## PRODUCT/PROCESS CHANGE NOTICE (PCN)

<b>PCN #:</b> TB1303-01 <b>DATE:</b> April 1, 2013 <b>Product Affected:</b> TQFP-32, TQFP-48 shipped in <b>Tape &amp; Reel</b> (Refer to Attachment II for affected part#) <b>Date Effective:</b> <b>July 1, 2013</b>	<b>MEANS OF DISTINGUISHING CHANGED DEVICES:</b> <input type="checkbox"/> Product Mark <input type="checkbox"/> Back Mark <input type="checkbox"/> Date Code      Shipment starting from July 1, 2013. <input checked="" type="checkbox"/> Other
---	---

### ATTACHMENT I - PCN #: TB1303-01

**Detail of Change:** This notification is to advise our customers that IDT has qualified a new revision of a carrier tape for packages TQFP-32 and TQFP-48.

**Figure1: Illustration on Existing Carrier Tape and New Carrier Tape**

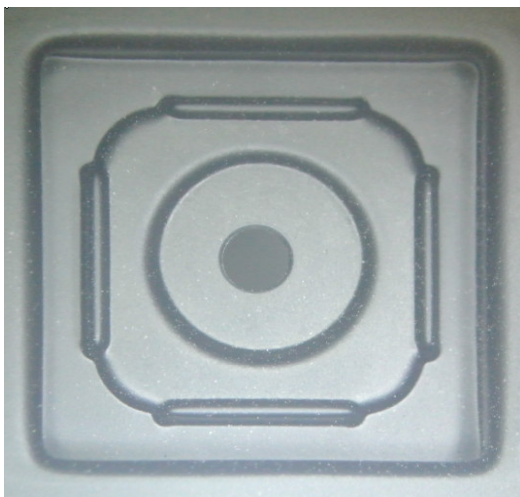
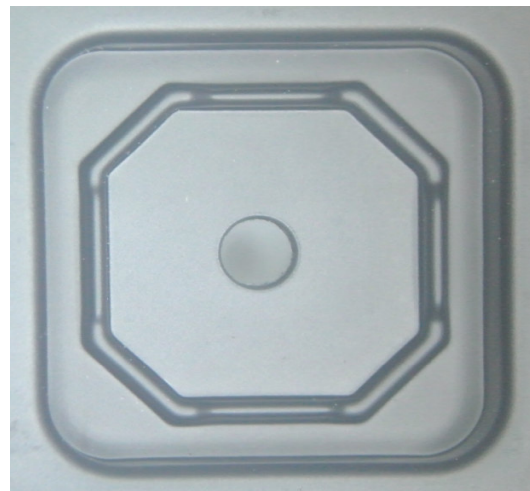
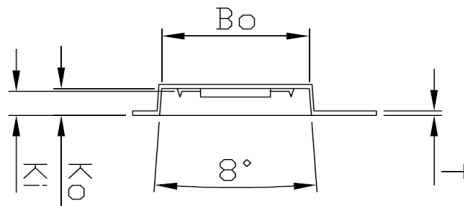
The new carrier tape has changes in pocket dimensions and design that enhances pick and place function during board mount process. The new carrier tape is designed with increased pocket depth from 1.3mm to 1.55mm, which will avoid unit protruded above the top surface of the carrier tape.

Existing Carrier Tape-  
Pocket Design

New Carrier Tape-  
Pocket Design

Existing Carrier Tape-  
Pocket Dimension

New Carrier Tape-  
Pocket Dimension
